Ref: P100221

## Response to Additional Information – PPSSEC-214/DA-2022-16 at 47A Wentworth Road, Strathfield

## Response to Concept Development Plan

**Figure 1** Summary of Major Discrepancies

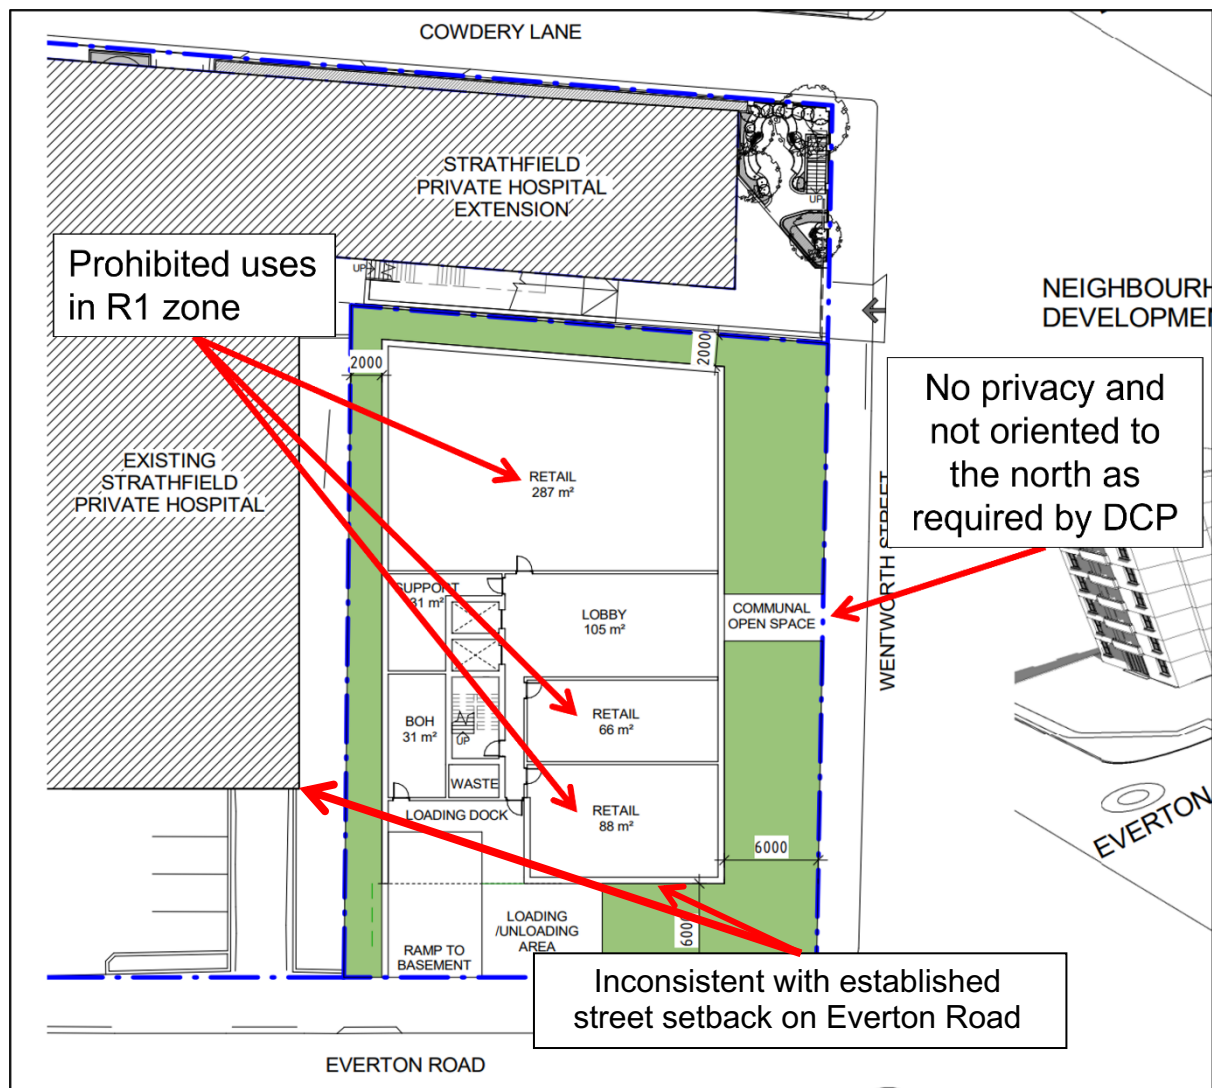
It is acknowledged that the applicant has prepared concept development plans as requested by the Sydney Eastern Planning Panel. However, there are a number of discrepancies with the plan prepared by the applicant (summarised in the following figure), which have been addressed under separate headings below.

The concept development plans illustrate a building with ground floor retail and commercial uses with residential accommodation above (shop-top housing). This is inconsistent with the permissible uses within the R1 zone and broader market expectations for development in the area. Both **commercial premises** (a group term) and **retail premises** (a 'type' of commercial premises) are prohibited in the R1 zone and it is unlikely that the ground floor of any residential flat building at 1 and 1A Everton Road would be utilised for anything other than residential accommodation.

It is noted that the only form of commercial development permissible in the R1 zone is **neighbourhood shops** – however, Clause 5.4(7) of the *Burwood Local Environmental Plan 2012* limits neighbourhood shop developments to no more than 80sqm. **The proposed ground floor commercial use is therefore not permissible under the requirements of the *Burwood Local Environmental Plan 2012*. The proponent has produced inaccurate plans, proposing uses that are prohibited by, and inconsistent with, the requirements of the LEP, incapable of being approved.**

Based on the above, the accompanying concept development plans **do not accurately reflect the likely development outcomes of 1 and 1A Everton Road**. It is considered that the applicant has illustrated the ground floor component as commercial/retail, rather than residential, **as the use of the ground floor for residential purposes would not receive sufficient solar access to meet the requirements of the DCP**.

The location of 'communal open space' as identified on the concept development plan is unrealistic and would not provide appropriate privacy and amenity for future residents. The communal open space is located directly between the proposed active street frontage and would be visible from both the streetscape and the retail components of the development. The communal open space is also oriented to the east and is inconsistent with the following controls under Section 4.1 of the *Burwood Development Control Plan*.

The location of the communal open space between the active ground floor use and streetscape will provide no visual privacy for residents. The concept plans are inconsistent with the above control.

The proposed communal open space is oriented to the east. It is considered that the orientation of the communal open space to the east was chosen as a northern orientation would not receive sufficient solar access.

As noted above, the communal open space would be visible from the streetscape and public domains of Everton Road and Wentworth Road. The space does not achieve visual privacy.

It is unclear whether the eastern communal open space would receive sufficient solar access. Should the communal open space be re-oriented to the north (as is required under the DCP), the space would not receive sufficient solar access.

In the **likely** event that the ground floor of any future residential flat building at 1 and 1A Everton Road were to be used for residential purposes, it is evident that the ground floor dwellings would not receive sufficient solar access. This is reflective of the current conditions of the site, in which the existing dwellings receive insufficient solar access due to the existing hospital development to the west.

It is noted that no basement level plans have been prepared as part of the concept development plans supplied by the applicant. The original public submission(s) provided by our firm raised concerns over the potential impact the proposed basement level would have on similar subterranean development on the adjoining sites. It is unclear from the provided documentation whether subterranean structures on adjoining properties would require a setback that exceeds the DCP requirements due to the boundary basement structure proposed at 47A Wentworth Road.
